DA/25/2021 – Further Advice Response

Gladstone Hydrogen Park Quantitative Risk Assessment

AE21016-R01 Rev 1

AGIG HyP Gladstone Project – Summary of Asset Management Approach and Response to Further Submissions

Figure 5-2 7 kPa Overpressure Frequency Contours

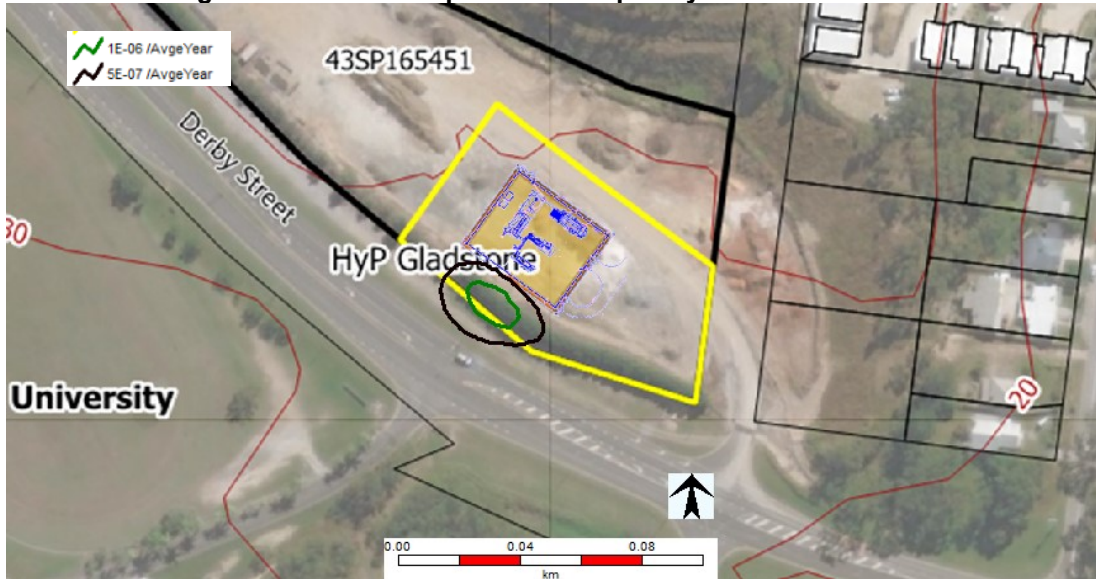
The centre of the explosion, as presented in QRA Report Figure 5-2, is the vegetation between the facility and Derby Street. Having this location as the origin of the congestion and mixing leading to an explosion is credible, as was reported for the investigation into the 2005 Buncefield UK fuel storage facility explosion (Ref. 33).

Figure 2-1: Bureau of Meteorology mean wind speed

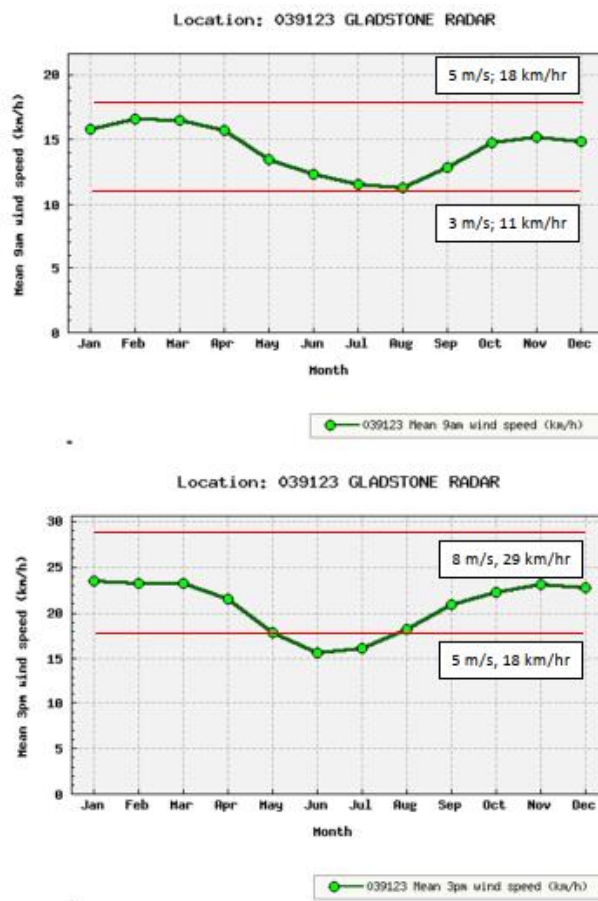
There is an inconsistency in wind speed selection between the QRA Section 3.1 and QRA Appendix B Assumption Sheet 3 as noted in Table 2-1. It is recommended that the wind speed inconsistency be resolved.

The selection of these wind speeds is not specified in QRA Figure B-1, which is an annual wind rose. The BoM charts of 9 a.m. and 3 p.m. mean wind speed shown in Figure 2-1 were downloaded from the BoM site and indicate that the lower wind speeds stated in QRA Section 3.1 would better reflect local conditions. Higher wind speed will have little impact on jet fires, however for cloud dispersion and flash fires, higher wind speed reduces the size of the consequence and risk. The QRA impact is expected to be minimal.

Recommendation	Review Reference
1. Clarify the inconsistency in wind speed selection between the QRA Section 3.1 and QRA Appendix B Assumption Sheet 3.	2.3.1 Weather conditions

Figure 2-2: Details from the Hydrogen Storage P&ID GLA-G-100-01

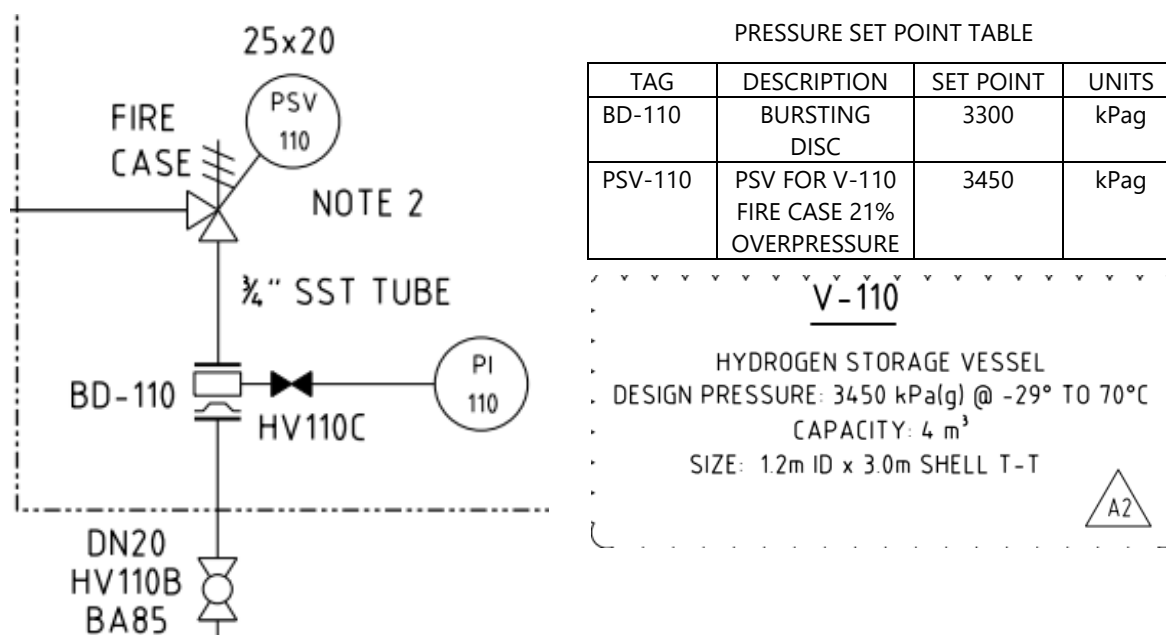
Inventory properties are listed in QRA Table 3-1. The pressures for system PS1, PS2 and PS4 are accepted as valid. The hydrogen storage pressure of 32 kPag (refer Table 2-2) appears inconsistent with the hydrogen storage P&ID GLA-G-100-01 Rev A2 (refer Figure 2-2) which states the design pressure is 3,450 kPag. It is recommended that the correct pressure value for system PS3 in the QRA model be confirmed.

Consideration of QRA Report Table 4-3 shows the same consequence for PS2 and PS3 for the same hole size releases (2mm and 22mm). This may support the conclusion that the QRA model utilises the correct higher pressure for PS3 inventory and the pressure in the QRA Table 3-1 is incorrect (a typo).

2. Clarify that the pressure for PS3 hydrogen storage used for consequence assessment is the design pressure of 3,450 kPag (P&ID GLA-G-100-01) and not 32 kPa (QRA Table 3-1).	2.3.3 Maximum Pressure

Figure 2-4: LSIR Contours from QRA Report Figure 5-3

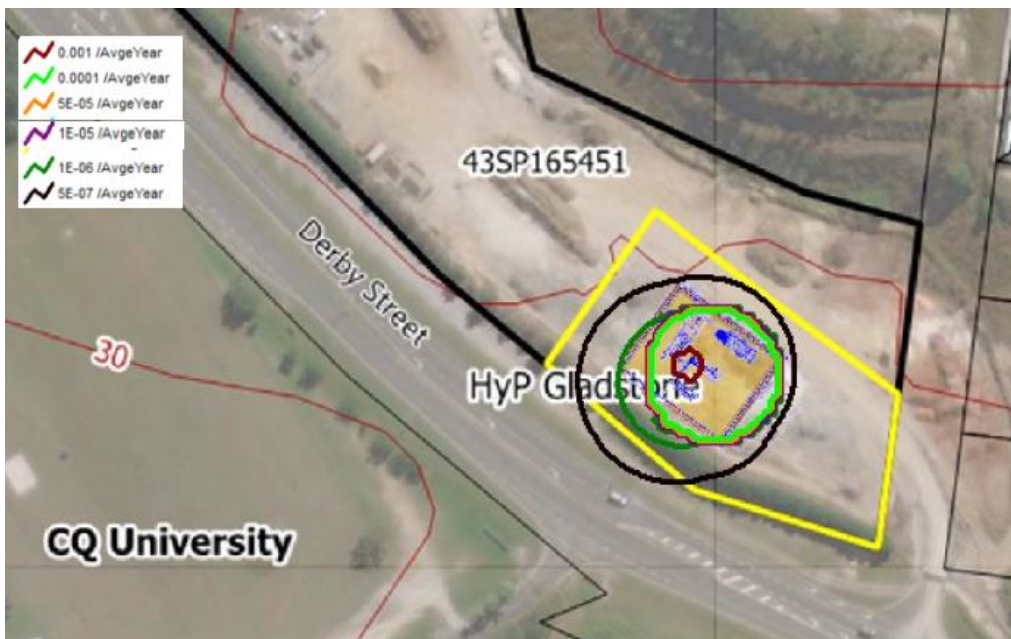
Risk contours calculated in the QRA study are shown in Figure 2-4 (copy of QRA Figure 5-3). It is estimated that:

- there is approximately 60 m separation from the 1×10^{-6} /year risk contour (indicated in dark green colour in Figure 2-4) to the closest residential land use
- there is approximately 175 m from the 0.5×10^{-6} /year risk contour (indicated in black colour in Figure 2-4) to the closest school boundary.

Therefore, the risk contribution from the site, calculated in the QRA, is considered tolerable risk using the SDAP criteria.
